APPLICATION NO.	FILING DATE	FIRST NAMED INVENTOR	ATTORNEY DOCKET NO.	CONFIRMATION NO.
10/585,091	03/23/2007	Anthony Michael Ging	JPD-4398-559	5781
23117 7590 10/15/2010 NIXON & VANDERHYE, PC 901 NORTH GLEBE ROAD, 11TH FLOOR ARLINGTON, VA 22203				
EXAMINER				
PATEL, NIHIR B				
ART UNIT		PAPER NUMBER		
3772				
MAIL DATE		DELIVERY MODE		
10/15/2010		PAPER

Office Action Summary

DETAILED ACTION

FIG. 44

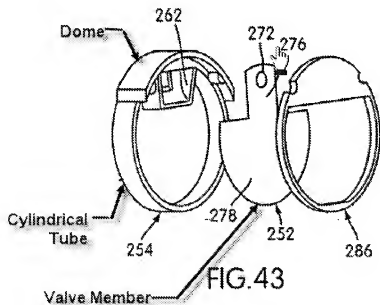
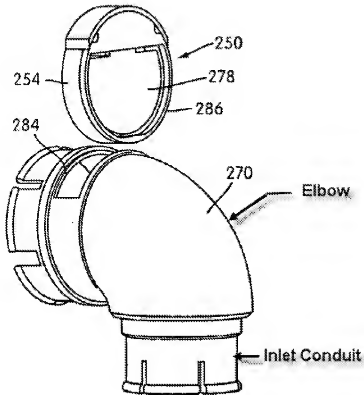
13. **As to claim 58**, Dantanarayana teaches an apparatus that comprises a frame **32 (see fig. 4; paragraph [0071])**; an elbow **(see fig. 44)** provided to the frame and including an inlet conduit **(see fig. 44 below)** and a valve member **278 (see fig. 43 below)** provided at an interface of the elbow in the frame, the valve member being configured to allow breathing of ambient air and to prevent back flow of gas towards the inlet conduit of the elbow in an unpressurized state **(see fig. 42; the figure shows arrows in both direction in the exhaust port indicating that that it allows breathing of ambient air and the fact that the valve 278 is closed prevents back flow of gas towards in the inlet conduit).**

14. **As to claim 59**, Dantanarayana teaches an apparatus wherein the elbow includes an internal cylindrical tube **254 (see fig. 43 below)** in communication with atmosphere and a dome **(see fig. 43 below)** that supports the tube, and wherein any back flow is guided through the tube and not the inlet conduit in the unpressurized state.

15. **As to claim 60**, Dantanarayana teaches an apparatus wherein the elbow includes at least one inlet slot structured to allow ambient air to be channeled between the valve member and the frame for supply to the patient, when operating in the unpressurized state (see fig. 42; the figure shows arrows in both direction in the exhaust port indicating that that it allows breathing of ambient air and the fact that the valve 278 is closed prevents back flow of gas towards in the inlet conduit).

16. **As to claim 61**, Dantanarayana teaches an apparatus wherein the valve member is structured to separate from the tube during operation in a pressurized state, to thereby allow pressurized gas to enter an aperture of the frame (fig. 40 shows that the valve member is separated from the tube 254 during operation in a pressurized state, allowing gas to enter an aperture of the frame).
